AMENDMENT NO. 14

EAST WANNEROO CELL 5

AGREED STRUCTURE PLAN NO.7

PART 2 - EXPLANATORY REPORT

Proposed Structure Plan Map

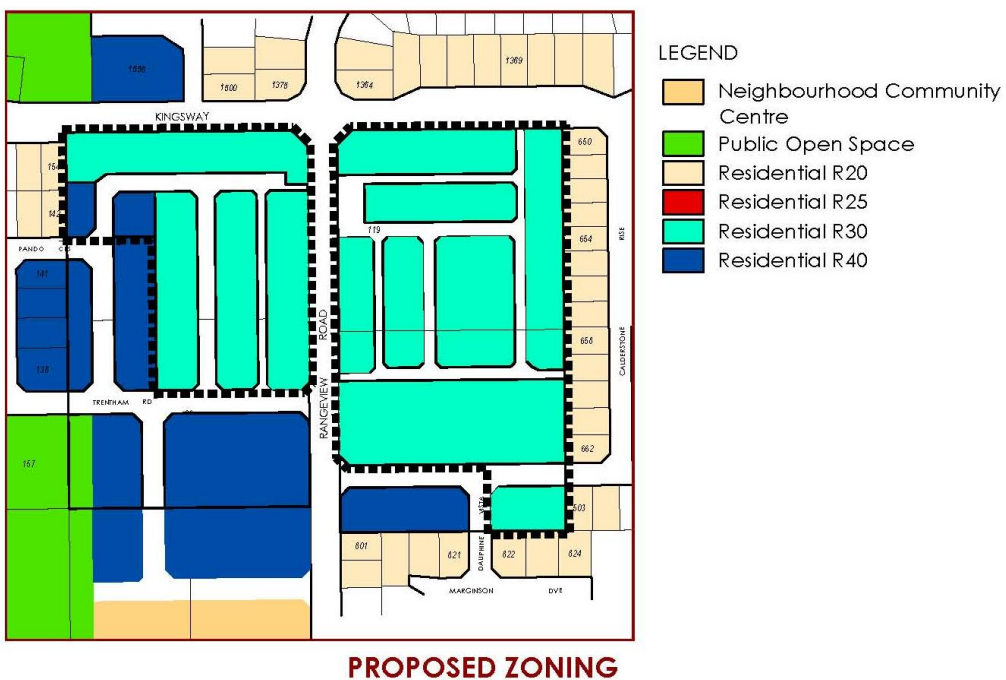
To modify the Structure Plan Map as follows:

To modify the road network and replace portions of the land shown as Residential Density Code R20 and R25 with a Residential Density Code of R30 and R40 as it affects those portions of Lot 25 (No.8) Rangeview Road, Lot 26 (No.26) Rangeview Road, Lot 120 (No.19) Rangeview Road and Lot 119 (No.390) Kingsway, Landsdale as depicted on the Proposed Zoning plan.

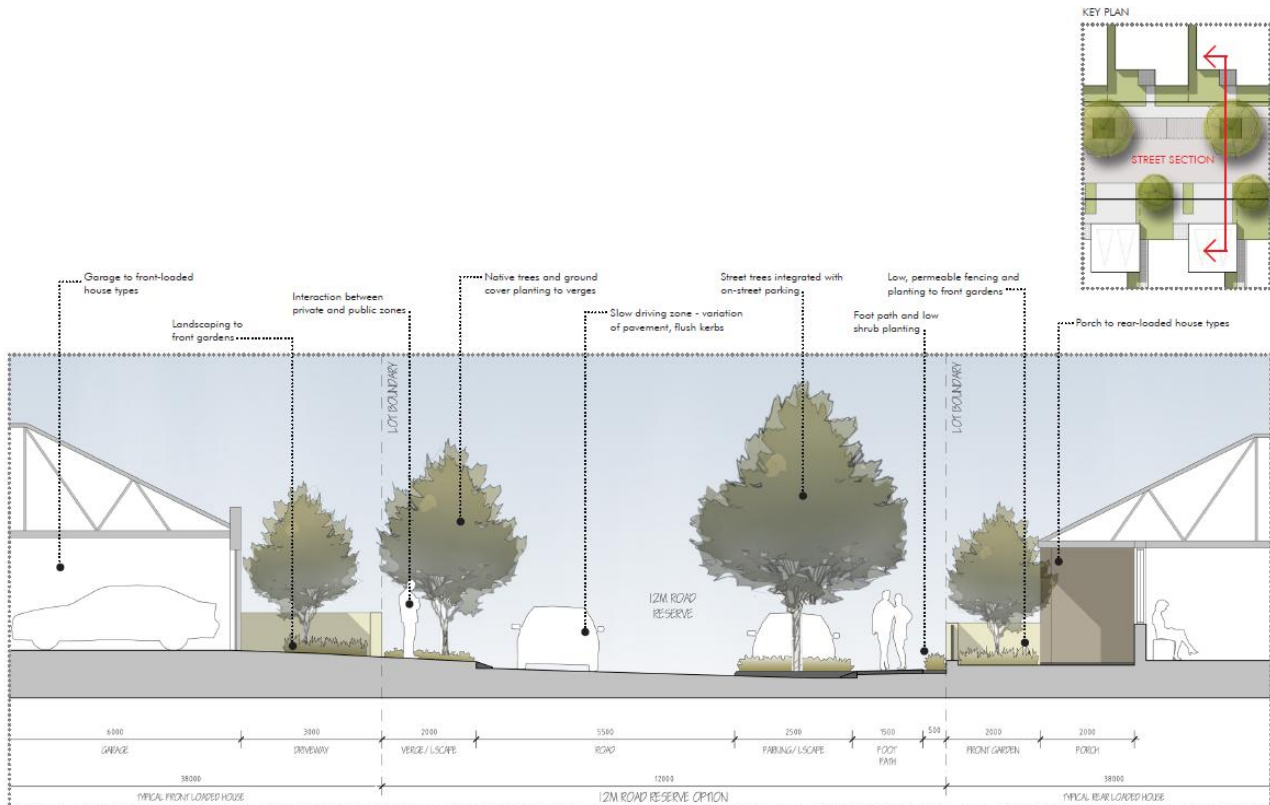
In addition to the recoding, the amendment seeks to modify the road layout in accordance with the concept subdivision plan attached herewith. We note that two of the proposed roads feature 12 metre reserve widths (being the central north-south road, and the northern east-west road). Given that these roads will only cater for internal traffic (i.e. they do not form any external connections), and that only 27 lots gain direct access to these roads, (which is expected to result in approximately 270 movements per day (at 10 trips per dwelling)), a reduced reserve width is considered appropriate.

The visioning document attached herewith outlines the form of residential character that is being sought; and includes a detailed overview of the design and materials that are to be used to create an environment of high quality and a high level of amenity. To that end, the reduced verge widths have been shown to provide a high level of functionality for both pedestrian and vehicular traffic by providing standard road pavement, parking, and footpath widths (refer above cross-section).

Landscaping will also be used to delineate and buffer the areas for pedestrian and vehicular traffic. As shown in the cross-section, pedestrians will be 'cocooned' by street trees, parking areas, and low shrubs that serve to create a more enclosed and appropriable space where activity from the street and dwellings can take place, thereby encouraging social interaction between residents and walkers-by.
